Job Title	205 Lud Valley Road Subdivision
Job Reference	19029-LET-001

Flow Environments Limited (FEL) have been engaged by Andrea and Paul Vincent (the Client) to respond to questions 11 to 14 of a request for information related to a Resource Consent application for subdivision of 205 Lud Valley Road, Hira.

Figure 1: CGW investigation and disposal field locations.

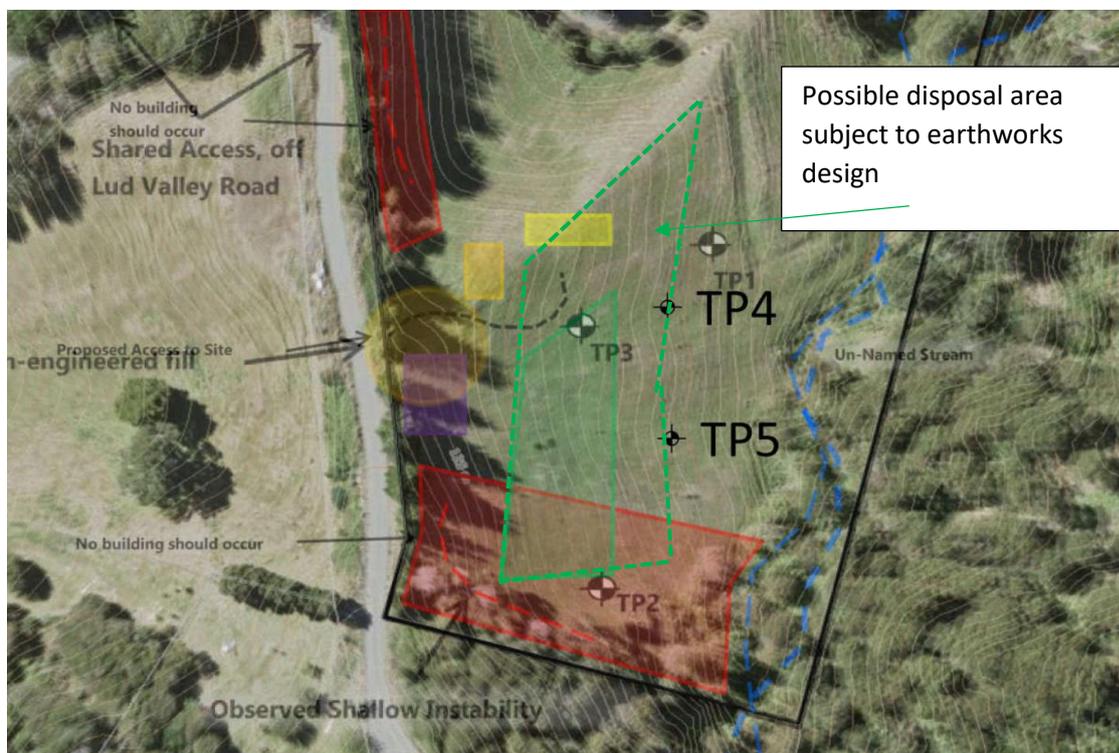
12. The tests pits used to determine the soil type/ category of the disposal area are located outside the area proposed for the wastewater field. Please provide a soil evaluation, including soil investigations of the actual disposal area (Note: as per ANZS1547:2012 a detailed subsoil investigation shall examine and record the soil profile and solid features within the expected available areas).

Two figures from the CGW report showing the test pit locations and the proposed disposal field have been merged as shown in Figure 1 below. TP2 and TP3 are within the disposal field (green box), or close enough to have no material effect on the conclusions of the report. Following this investigation, the Client has indicated that the disposal field may be relocated further down slope. Two additional shallow test pits (TP4 and TP5) were excavated to a depth of 500mm in the two locations marked on Figure 1. These test pits were excavated 20m from the waterway, the furthest downstream extent of any disposal field. From a wastewater perspective, soil conditions in these two test pits were similar to those encountered in the CGW investigation with dark brown sandy clay topsoil to 280-300mm below ground surface and medium brown strongly structured sandy clay beneath this. Angular gravel inclusions were identified in both holes, more frequently in TP4. The strong, granular structure of the soil and the presence of frequent gravel inclusions will promote good drainage. The relatively conservative assessment of Category 5 soils with a disposal rate of 1.5mm/day and the avoidance of slopes greater than 35%, as concluded in the CGW report, is considered a sound design basis, applicable to the entire east facing slope where a disposal field could be constructed on site.

Figure 2: Indicative Field Location.

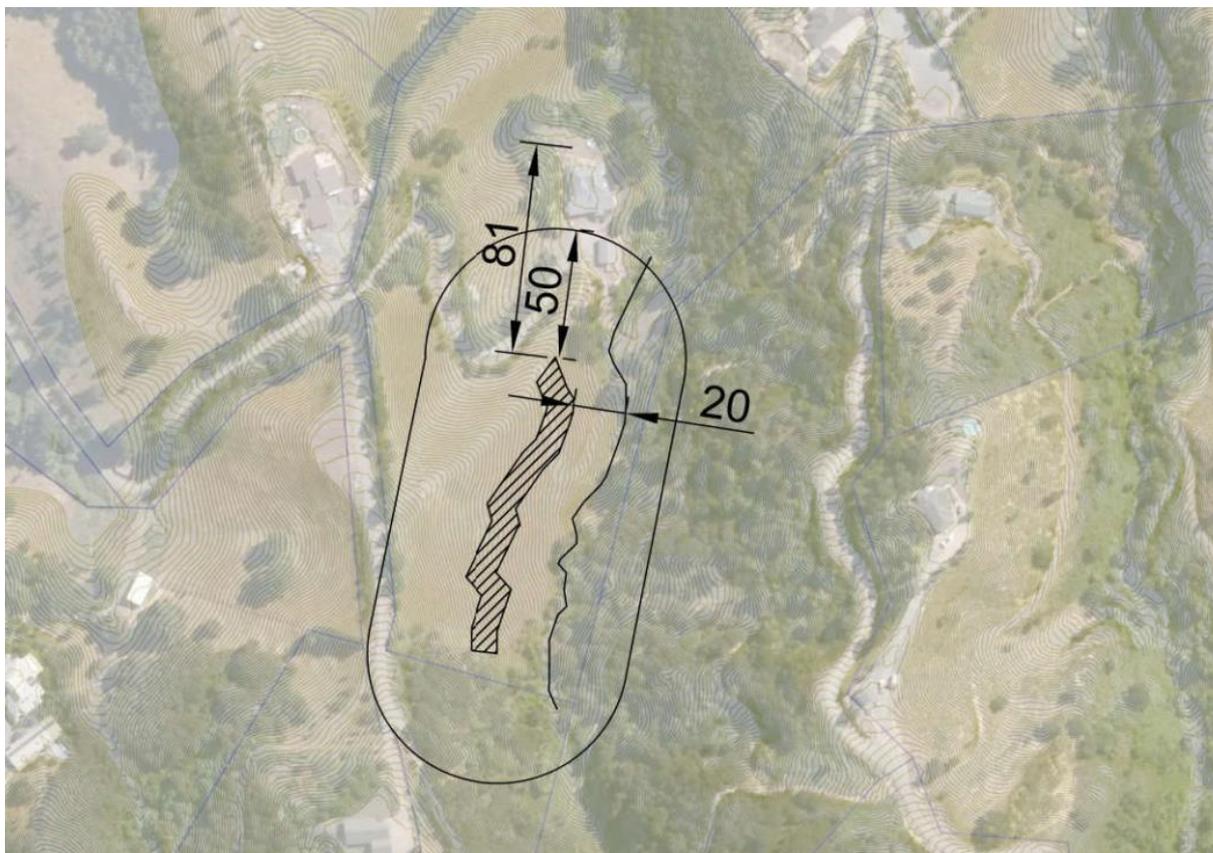
13. As noted in the CGW report, all elements of the proposed onsite wastewater management system require detailed design – this information is required for Council to process the discharge permit, please provide. In particular, the following information is required:

- a. Proposed effluent quality for secondary treatment (BOD₅, TSS) and location of a sampling point;
 - b. Tank size;
 - c. Exact location of the proposed disposal field and reserve area, including proposed drip line layout;

- d. Setback from nearest water body (I note the report, and FWr.291. recommend a minimum setback of 20m, but no exact measurement/ setback has been provided);

- e. Distance to nearest other disposal field, incl. existing field on Propose Lot 1;
 - f. Distance to nearest bore;
 - g. The requirement for and location of stormwater cut off drains;

- h. The requirement for visual and audible alarms;
 - i. Recommendations/ requirements for vegetation cover of the field;
 - j. Maintenance requirements & frequency.

From discussions with the Client, the exact field location may change once the earthworks design is finalised. At this point, it is recommended to keep the disposal field as far as possible from the earthworks to maximise flexibility in the site layout. A separation distance of 20m to the nearest water

body is proposed in the indicative layout below (item d). Again, the system designer should have flexibility when determining the layout of lines, subject to the conditions in the CGW report. It is recommended that if there is an elevation difference of more than 10m in the disposal field, the field is split into 2 zones with no more than 10m elevation difference per zone to minimise preferential disposal of effluent at lower elevations. Based on the layout plans at present, a field 10m wide and 88m long is recommended (item c). The elevation difference is less than 10m with this layout. The field location shown in Figure 2 below includes 1220m² of disposal area, exceeding the requirement of 880m² nominated in the CGW report. A reserve area is not specifically required by the NRMP however there is ample land within the nominated disposal area for additional wastewater field to be constructed. It is noted that for dripline, complete replacement of the field is unlikely. If remediation of the field is required, it is more likely that individual lines will require replacement if they are damaged. Ample land area is available for this to occur. The existing disposal field is in the order of 80m from the proposed new field (item e). FEL are unaware of any bores used for water supply in this area, a 50m offset from the disposal field (as required by the NRMP) is shown in Figure 2; there are no bores within this area. The distance to the nearest bore exceeds 50m (item f). The existing pasture vegetation cover is suitable for the disposal field. This should be maintained or enhanced with shrubs or other relatively small vegetation following installation of the field with stock access prevented (item i).

Based on the existing topography, there is no requirement for stormwater cut-off drains above the field as water will runoff relatively quickly. This should be reviewed once the earthworks design is complete. Again, piped stormwater from the house and shed should be diverted or piped away from the disposal field (item j)
